RECEIPT DATE: 11/7/23 **ONSITE SEWAGE DISPOSAL SYSTEM** P 575694  
 APPROVAL DATE: 7/9/2024 **PERMIT: New Construction** A \_\_\_\_\_  
 PROPERTY ADDRESS: 14510 Philadelphia Road  
 SUBDIVISION: \_\_\_\_\_ LOT: \_\_\_\_\_ TAX ID: \_\_\_\_\_  
 CONTRACTOR: Chris Enterprises Nathan Wimer EMAIL: \_\_\_\_\_  
 CONTRACTOR ADDRESS: 1044 Taylor Road Street MD 21151 PHONE: 443.686.2523  
 CONTRACTOR CERTIFIED FOR BAT INSTALLATION:  MDE  MANUFACTURER:  
 PROPERTY OWNER: Selo Musa EMAIL: \_\_\_\_\_  
 OWNER ADDRESS: 7330 Freebird Lane, Elkridge, MD 21075 PHONE: 443-742-0348

**From:** Silvast, Zackary  
**Sent:** Thursday, August 10, 2023 5:51 PM  
**To:** 'Dan Blevins'  
**Cc:** James Powell; Selo Musa; Williams, Jeffrey  
**Subject:** RE: 14510 Triadelphia Road

**ON-SITE SEWAGE DISPOSAL SYSTEM DESIGN NOTES AND DETAILS**

**DRAWING: ON-SITE SEWAGE DISPOSAL SYSTEM DESIGN PLAN**

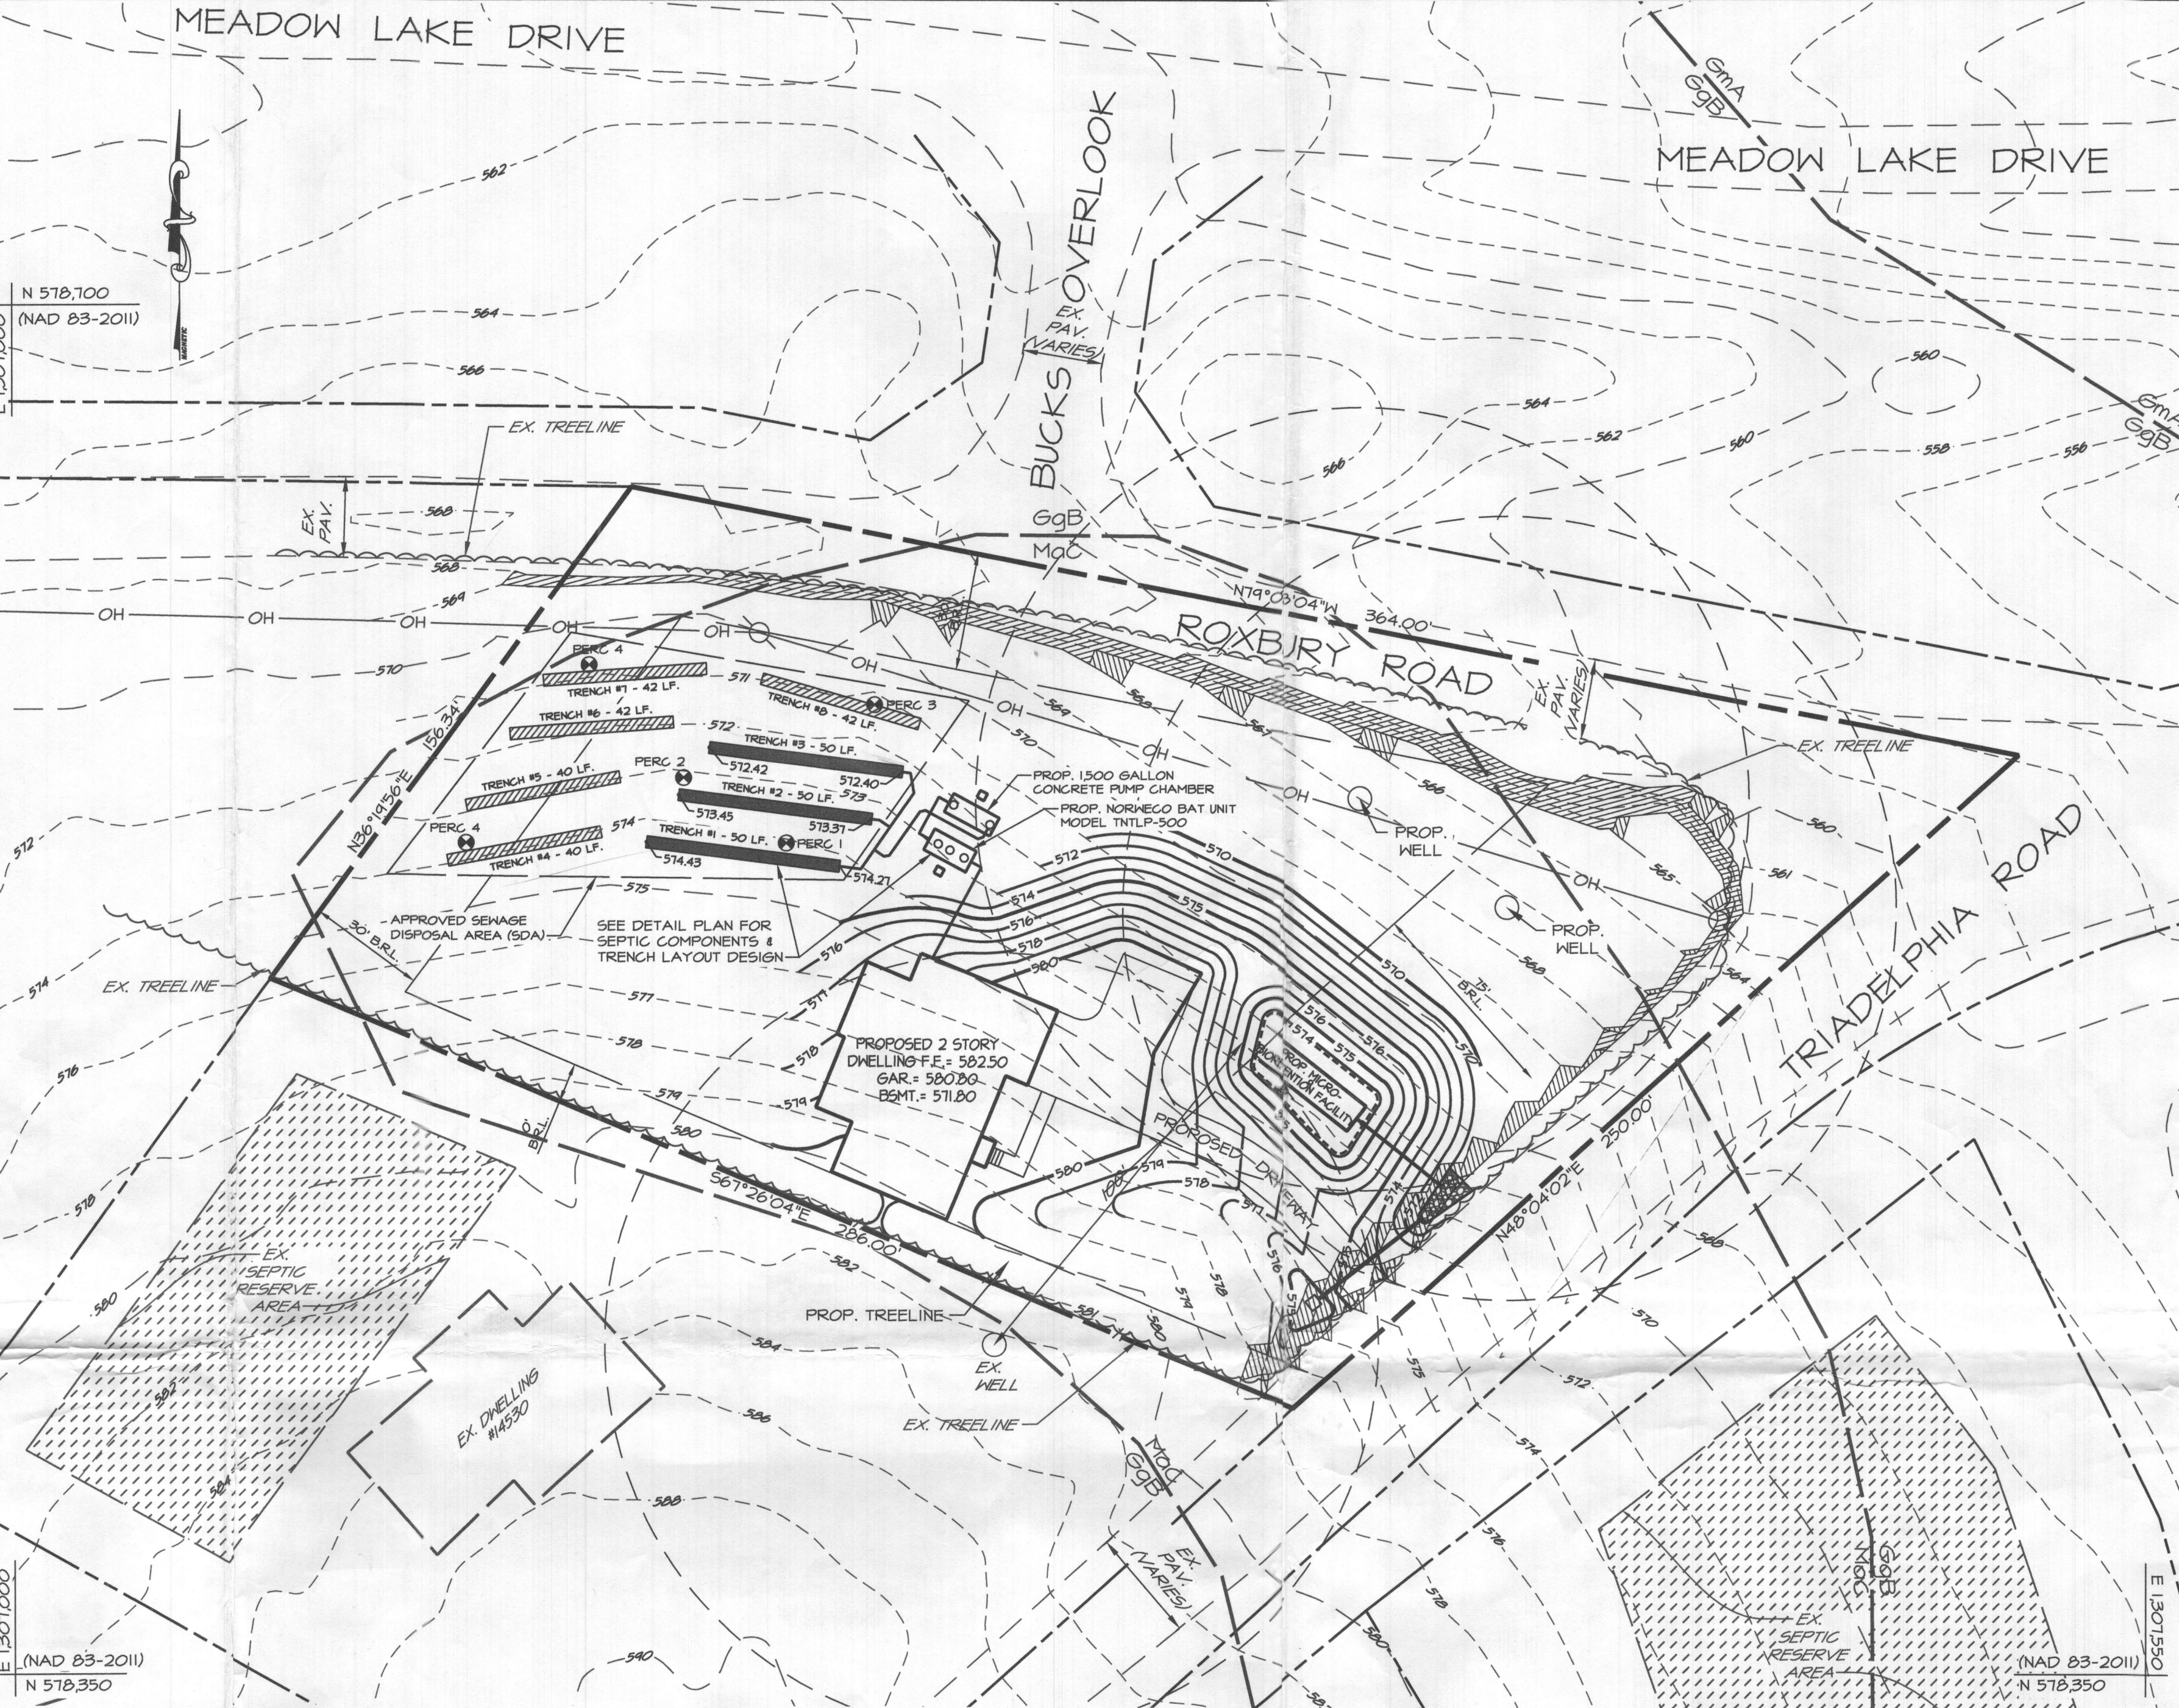
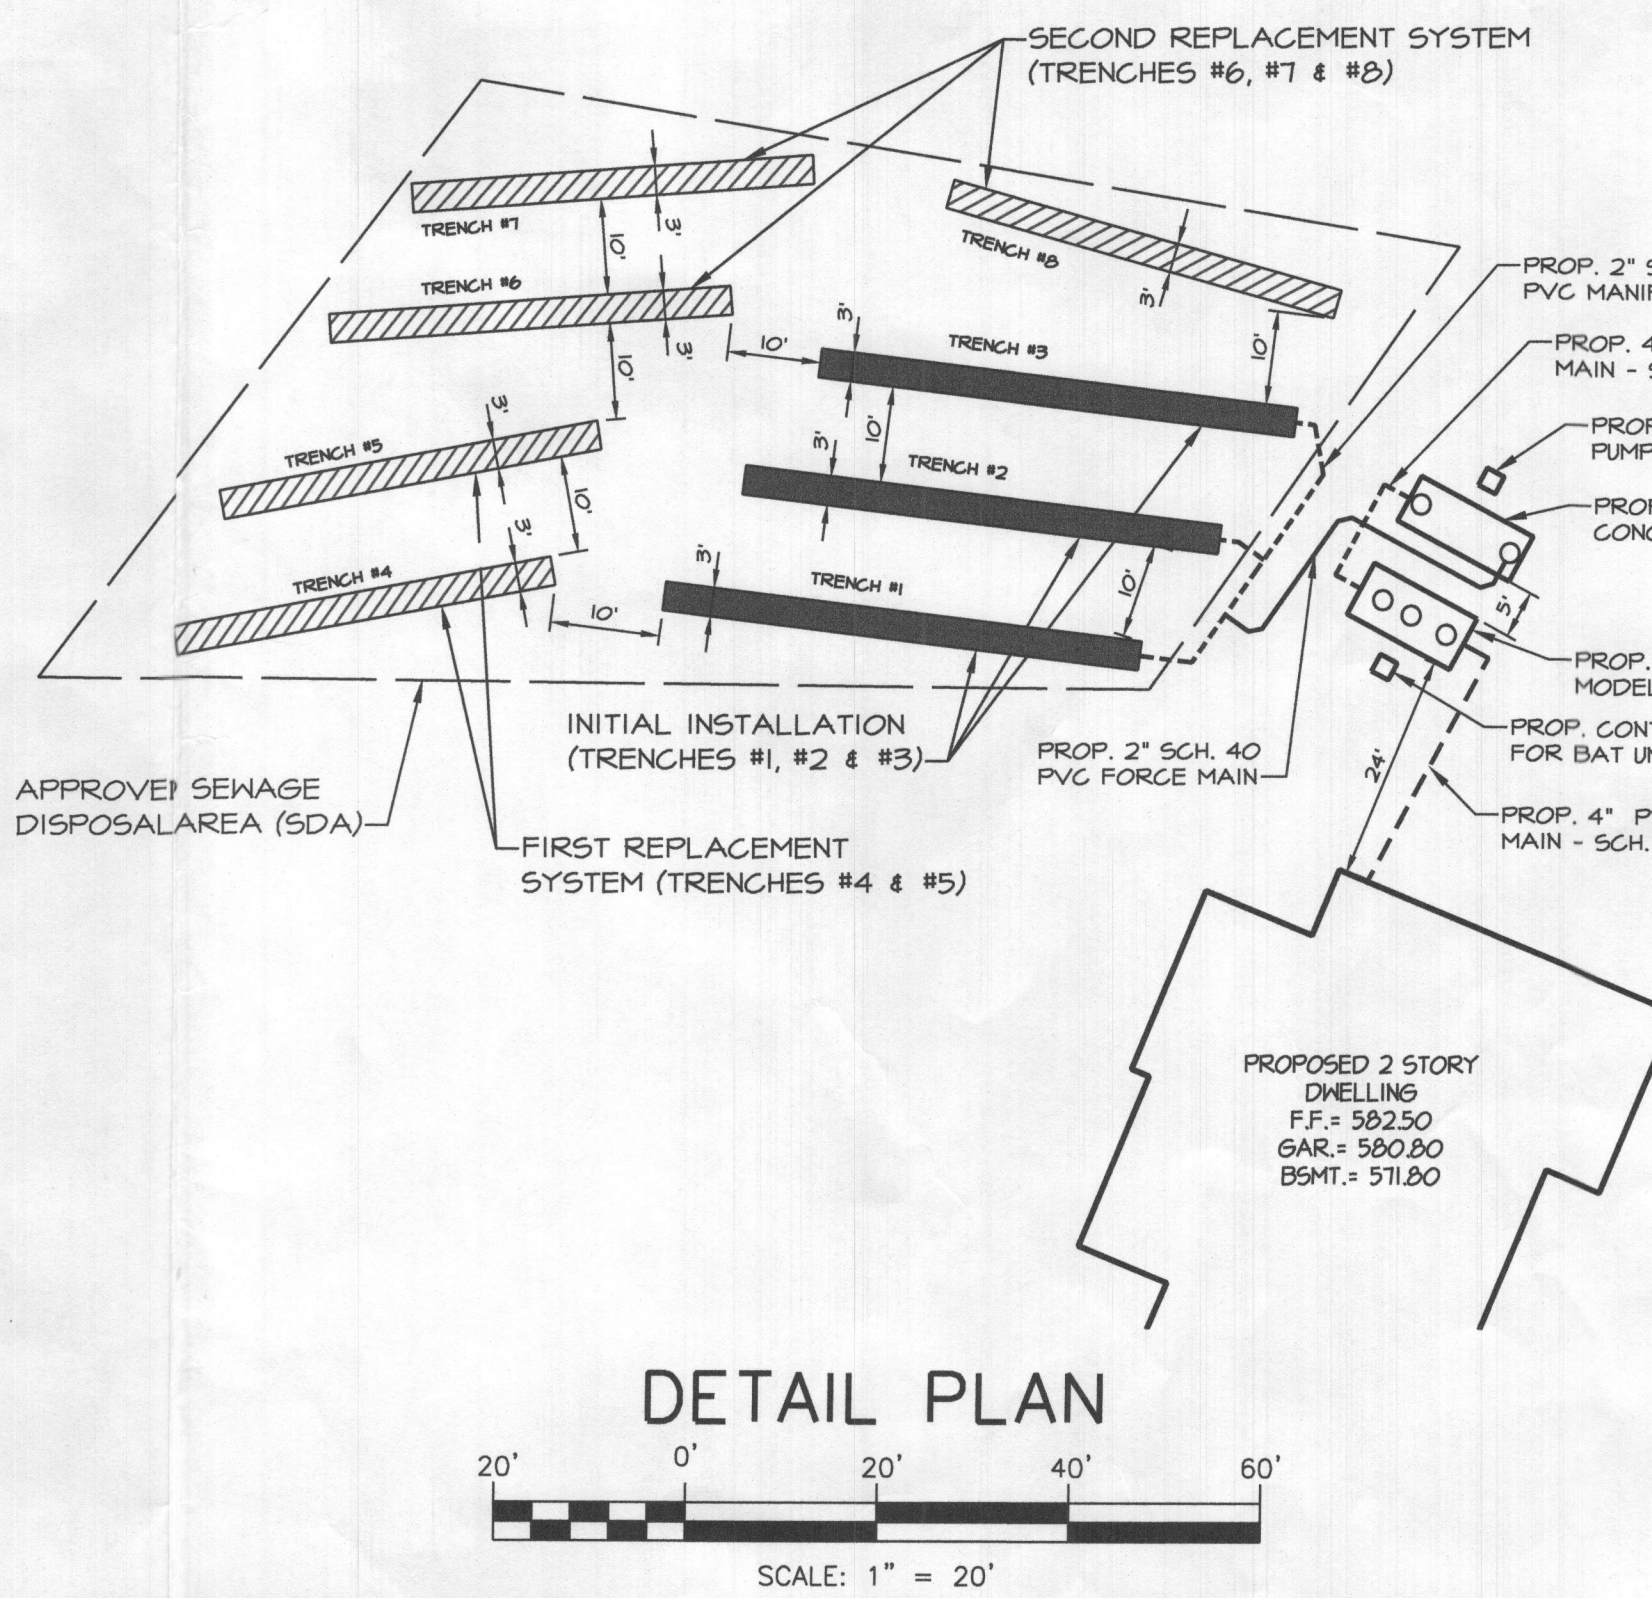
1. **We are fine with your perforation choice so as long as it brings balance to the LPD system. And it is accurate spacing along the entire lateral.**
2. **Regarding the dose, we are agreeing with your explanation and do not intend to pursue change. (again your design)**
3. **Regarding your rebuttal to comment 3, trench 3 is 85% of the trench 1 flow rate.**
  - a. **This will have to be corrected.**
4. **We recommend putting trench 1 invert deeper to lessen the elevation difference between trenches.**
  - a. **You should show three trench detail cross sections displaying the depths of gravel, invert elevations, effective depth and earth cover etc.**

1. The topography shown was field run to 1' but the layout shown was shot with use of a laser level and the start and ending of each trench in the installation area was adjusted to be within 0.2' of each other. The topography in the installation area will be adjusted to reflect the laser elevation shots. **WE WILL NEED TO REVISE THE CONTOURS ACCORDINGLY IN THE INSTALLATION AREA**

1. The topography shown was field run to 1' but the layout shown was shot with use of a laser level and the start and ending of each trench in the installation area was adjusted to be within 0.2' of each other. The topography in the installation area will be adjusted to reflect the laser elevation shots. SAM - YOU WILL NEED TO REVISE THE CONTOURS ACCORDINGLY IN THE INSTALLATION AREA

c. There is only one trench that is not straight (#6) and it will be straightened out. Trenches lengths were revised to be the same length for each repair installation. SAM - I AM ATTACHING THE REVISED DESIGN OF THE SYSTEM TO BE PLACED ON THE PLAN IN PLACE OF WHAT IS CURRENTLY SHOWN. PLEASE REVISE THE TRENCH LENGTHS ACCORDINGLY FOR EACH OF THE REPAIR SYSTEMS AND STRAIGHTEN OUT TRENCH # 6.

**VARIABLE HEAD LPD and TRENCH SPECIFICATIONS INSTALLATION SYSTEM**

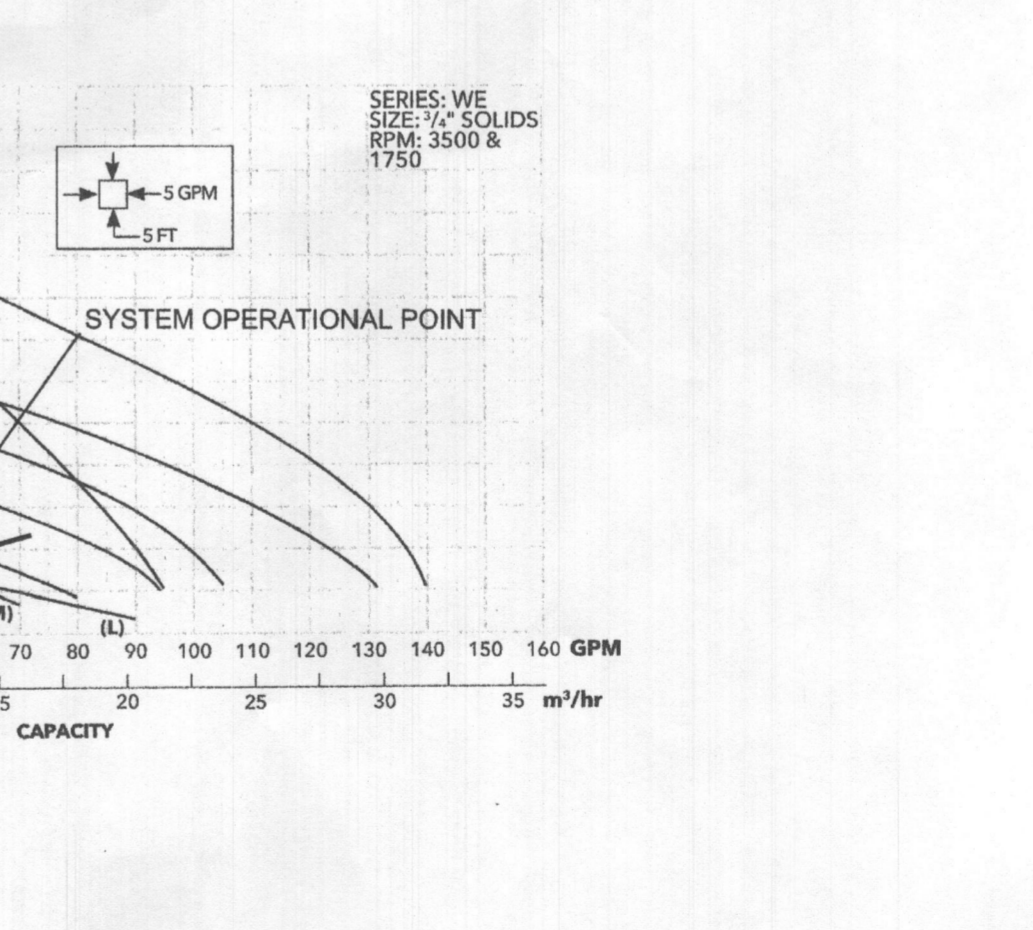
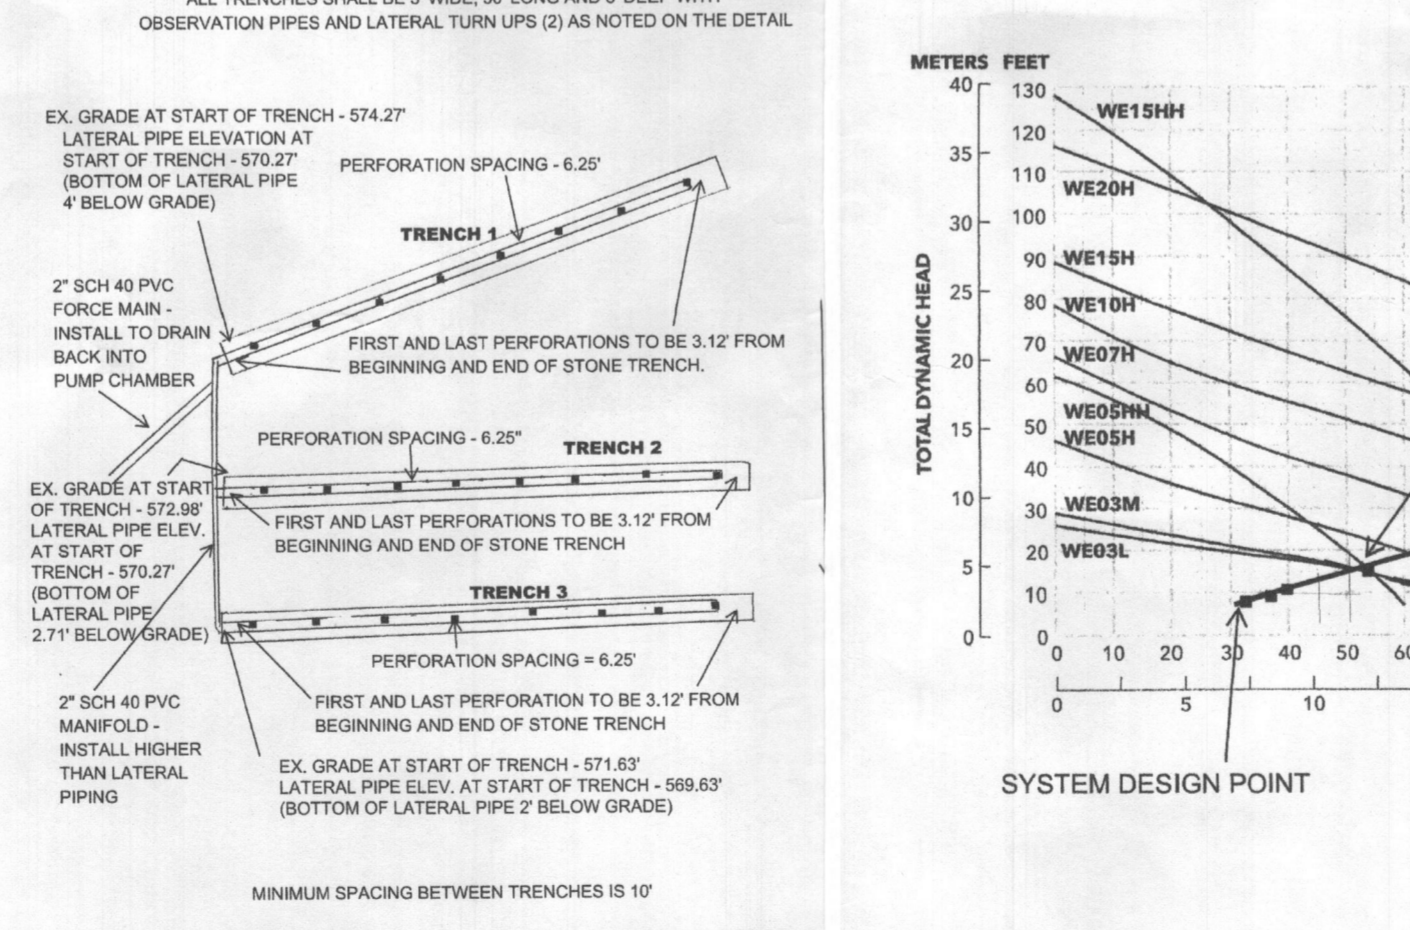
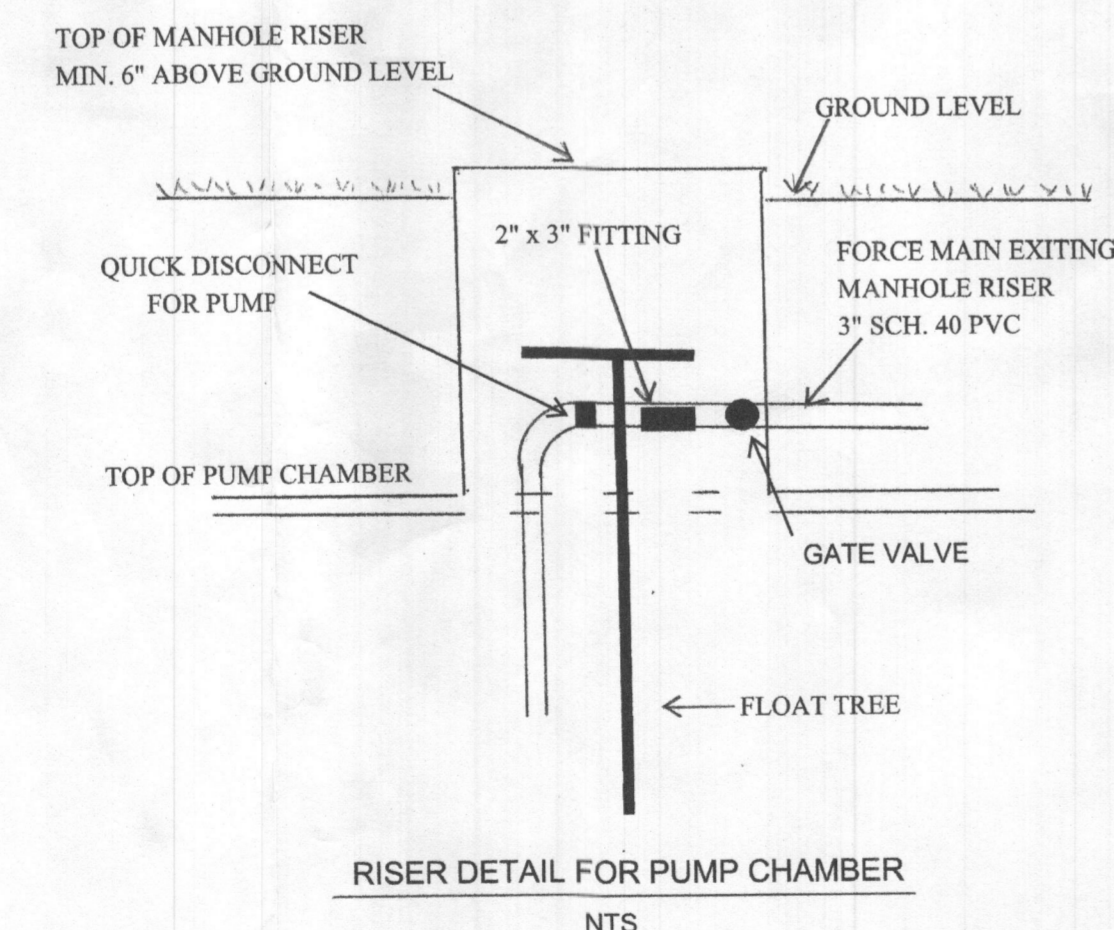
3. The flow per lateral must be within 10% of any two laterals. ((July 3, 2014 Draft of Basic LPD Design). If I use 5/16" perforations for all three laterals, in order to keep the flow for each lateral within 10% of each other, the orifice spacing for Trench 2 will be 8.33' and the orifice spacing for Trench #3 will be at 10'. The draft LPD draft design document noted above permits orifice spacing between 2' and 10'. Using the same size orifices would provide a flow rate of 2.09 gpm for Trench #2 as it is 1.29' lower than Trench #1; consequently the head pressure and hence the flow rate would be greater. Trench #3 would have an orifice flow rate of 2.48 gpm due to it being 2.64' lower than Trench #1. Also, the design draft document noted above permits use of 1/4" orifices when a BAT unit is employed and the head pressure is greater than 3'; both of which apply here.

5. To design the flow with 100 gallons being delivered to the trenches provides for a difference in elevation of 2.75" between the pump off and pump on float. Floats can lose accuracy over their working lifespan and a difference in even one inch from what was originally designed would increase (or decrease) the flow by 36%. Using a 4" float separation distance (as shown) would provide for a greater buffer in case the float accuracy changes by even an inch (ie: 25% less flow for a dose of 143.6 gallons would send 101.44 gallons to the trenches/dose). Whereas using a dose flow of 100 gallons with 25% less flow would send 75 gallons to the trenches - which is less than necessary to fully charge the lateral piping. I strongly recommend using the dose flow shown.

6. **Need a lateral trench detail/drawing showing a plane view of the trench wall.**
  - a. **A trench dissection showing lateral depth, depth of stone, earth cover, effective depth. (all properly labeled)**

- LATERAL 1 - total stone trench length - 50'
  - Perforation diameter - 1/4"
  - End feed manifold
  - 8 perforations
  - Perforation spacing - 6.25' (6' 3")
